In Reply Refer To:
HSSD/SS-135

Thank you for your letter of December 12, 2005, requesting the Federal Highway Administration's (FHWA) acceptance of your company's SPEEDsentry, SS12 and SS15, Radar Speed Displays mounted to a breakaway pole with a slip base as a crashworthy sign support system for use on the National Highway System (NHS). Accompanying your letter was a drawing of the system, system specifications with calculations, and reference to generic crash tests of similar devices. You requested that we find the SPEEDsentry systems acceptable for use on the NHS under the provisions of the National Cooperative Highway Research Program (NCHRP) Report 350 "Recommended Procedures for the Safety Performance Evaluation of Highway Features."

Speedsentry mounting for
NCHRP 350, 4" alum pole

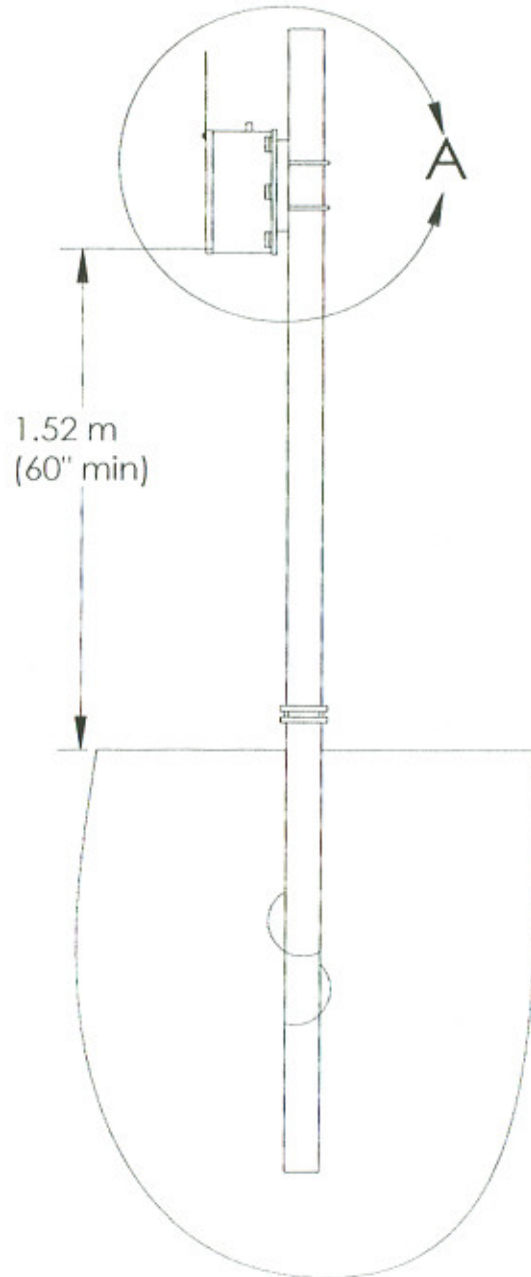
The SPEEDsentry 12 or SS12, is a radar speed display with 12 inch digit height, and the SS15 displays a 15 inch digit height. Both models are constructed of aluminum with a Lexan shield on the front. The SS12 weighs 32 pounds and the SS15 weighs 41.2 pounds with the "YOUR SPEED" display and without the battery. Each unit uses a standard 26Ah sealed battery, which weights 21 pounds for a total weight of 51 pounds and 62.2 pounds respectively. Each radar speed display is attached to a 4-inch diameter pole and the bottom of the unit is mounted at least 60 inches from the ground using 1/2 inch diameter U bolts as shown in the enclosed drawing.

Based on the results of your calculations and the previous testing referenced above, the SPEEDsentry installations are comparable and likely to meet the breakaway criteria under the

NCHRP Report 350. Therefore, the devices described above and shown in the enclosed drawings for reference are acceptable for use as test level 3 devices on the NHS under the range of conditions tested, when proposed by a State. This acceptance will be limited to a generic four-bolt slip base or a comparable base using crashworthy frangible couplings.
